Hi Dennis,

Here are our answers

Here are my concerns about your answers

eut-1updated

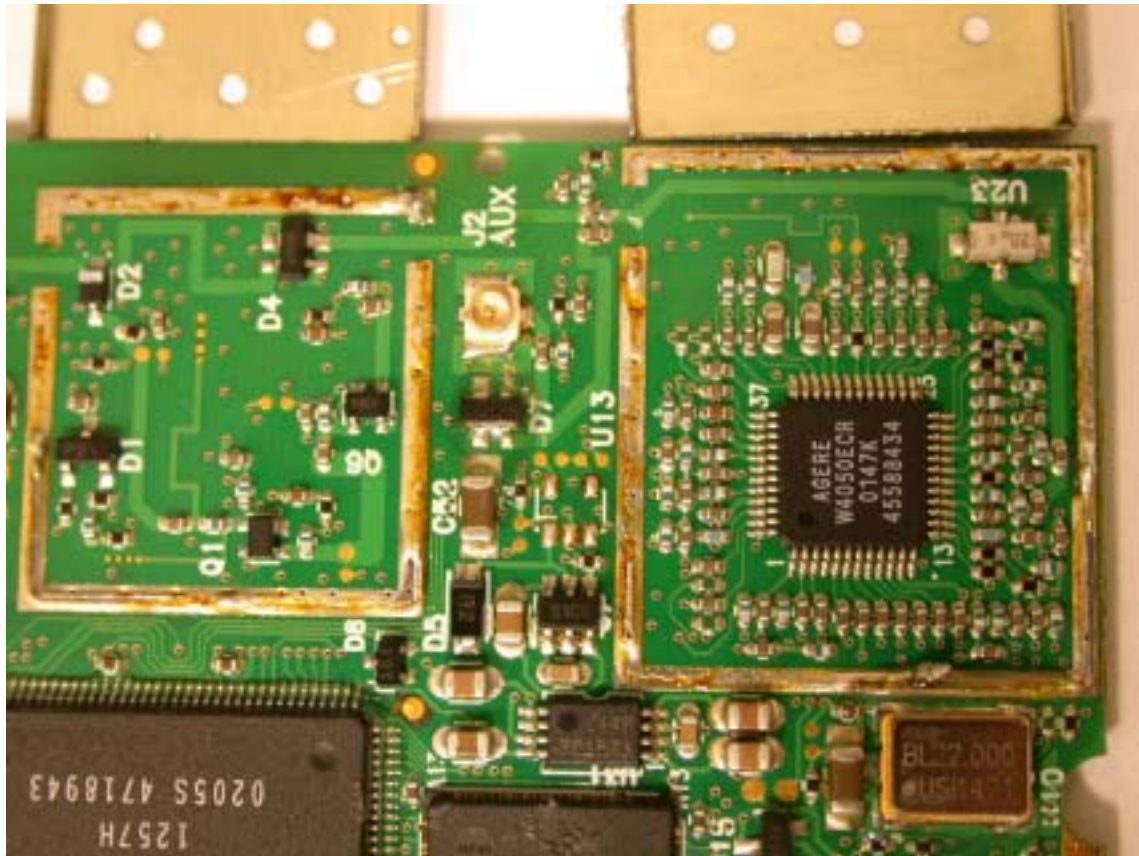
1 Your answer to item one is incomplete because it does not provide a separate photo of the circuitry under the metal shielding. This is required by the FCC. See 4 below

4 The photos of the circuitry under the shielding must be provided as a separate photo, not as part of the response document. The photos in the response document are blurred and are not adequate. Please provide separate photos that are clear.

**ANS 1: I re-uploaded the EUT photos into internal folders.**  
see exhibit type “internal photo” EUT-1a; EUT-1b; EUT-1c; EUT-1updated

**ANS 4: I re-uploaded the EUT photos into internal folders.**

**see exhibit type “internal photo” EUT-1a; EUT-1b; EUT-1c; EUT-1updated**  
(Same as item 1)
